## ZONING COMMITTEE STAFF REPORT

1. **FILE NAME:** Waterford Bay **FILE #:** 19-037-931
  2. **APPLICANT:** Stoneleigh Companies LLC **HEARING DATE:** May 23, 2019
  3. **TYPE OF APPLICATION:** Conditional Use Permit & Variance
  4. **LOCATION:** 380 Randolph Ave, Island Station Site
  5. **PIN & LEGAL DESCRIPTION:** 122823420020, SECTION 12 TOWN 28 RANGE 23 PART OF NE 1/4 OF SW 1/4 & SE 1/4 OF NW 1/4 & PART OF SW 1/4 OF NE 1/4 OF SEC 12 TN 28 TN 23 LYING SLY OF SHEPARD RD, NLY OF MISSISSIPPI RIVER, ELY OF ELY LINE OF TRACT A OF RLS 441 EXT NLY & SLY & WLY OF A LINE DESC AS BEG AT
  6. **PLANNING DISTRICT:** 9 **PRESENT ZONING:** T2, FF, FW
  7. **ZONING CODE REFERENCE:** §§ 61.501; 61.601; 61.202(b); 68.401-404; 68.601; 72.32; 72.63; 72.64
  8. **STAFF REPORT DATE:** May 16, 2019 **BY:** Josh Williams
  9. **DATE RECEIVED:** May 7, 2019 **60 DAY DEADLINE FOR ACTION:** July 5, 2019
-

- A. **PURPOSE:** Conditional use permit for a building height of 45' and for construction of a fire access road and storm sewers in the FW floodway. Variances for front yard setback >25', primary entrance location not in third of building closest to Randolph, and rehabilitation slopes >18%.

**EXISTING SITE CONSTRAINTS EXHIBIT**

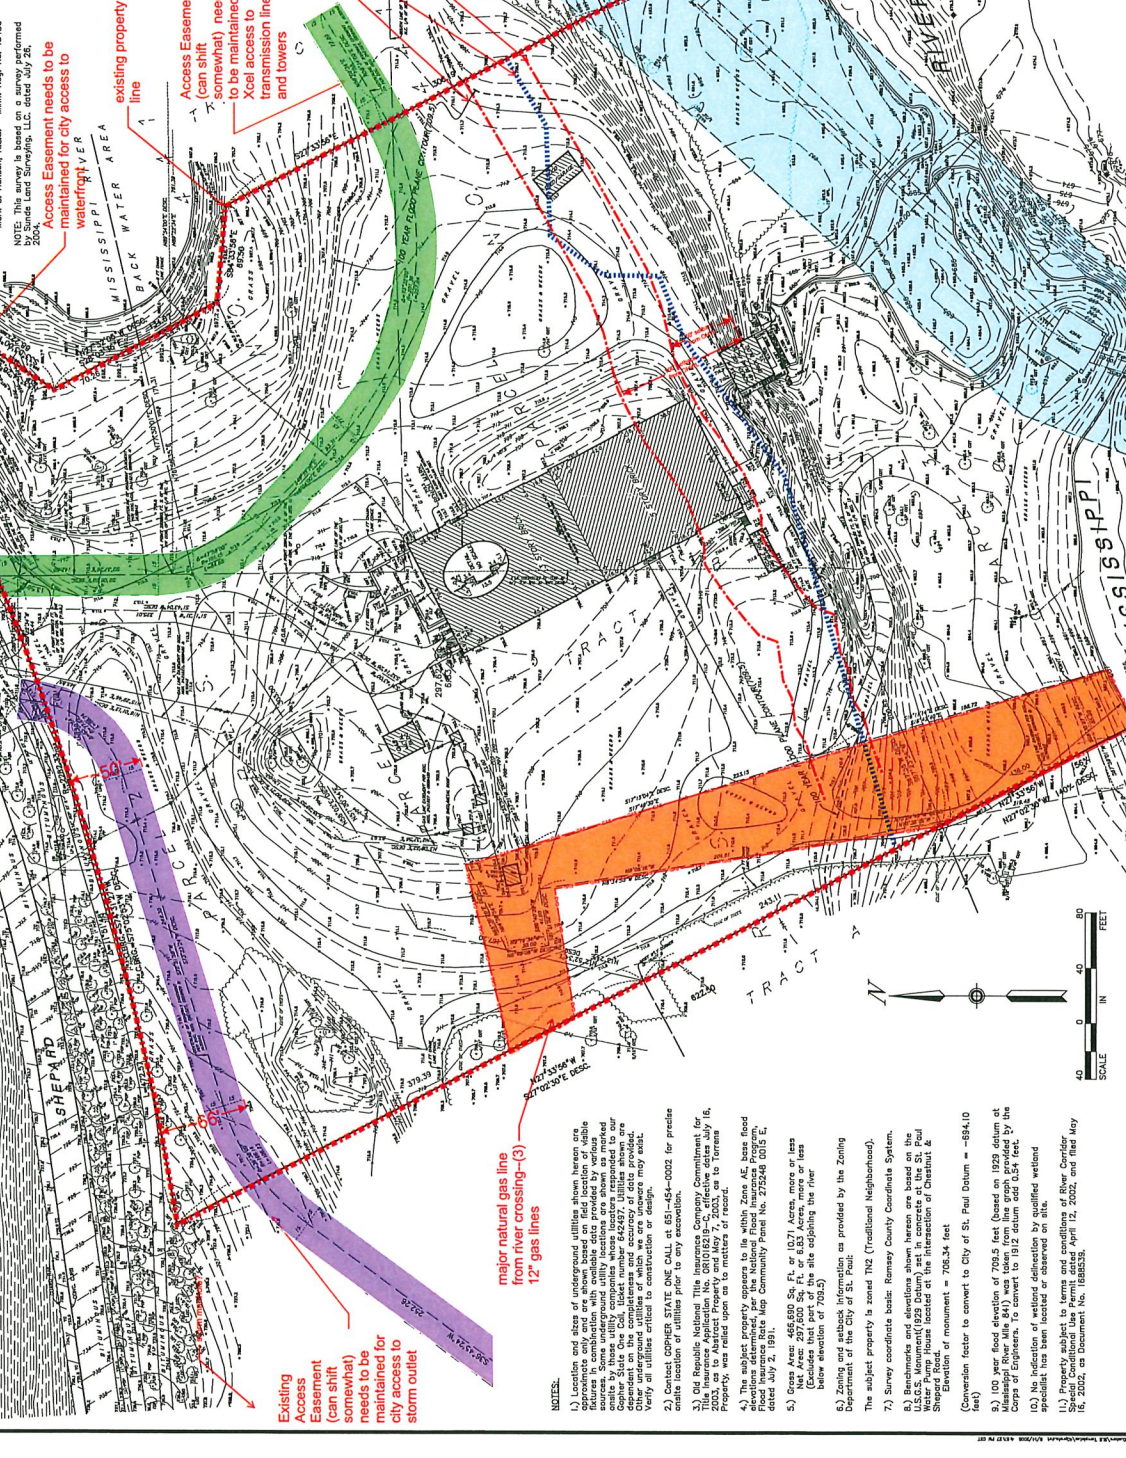
**Access Easement (can shift somewhat) needs to be maintained for city access to storm outlet**

**Access Easement needs to be maintained for water/tower**
